**P.T. NIGHT SIGHT**

November 4, 1991

As per my conversation with Mr John Lubinski I am requesting the following changes be made to our letter application for amendment, dated October 24, 1991.

DRAWING NO:  
BL3252

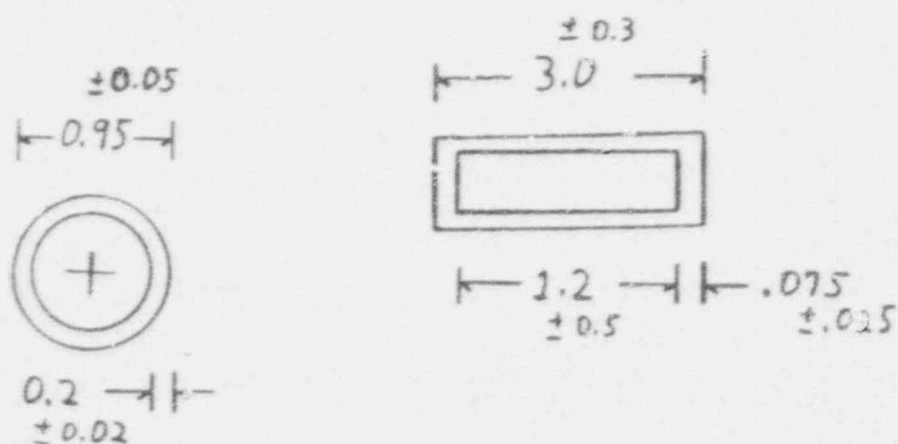
These attached drawing (BLS 251, BLS 252)  
replace Saunders- Roe Beta Light Drawings.
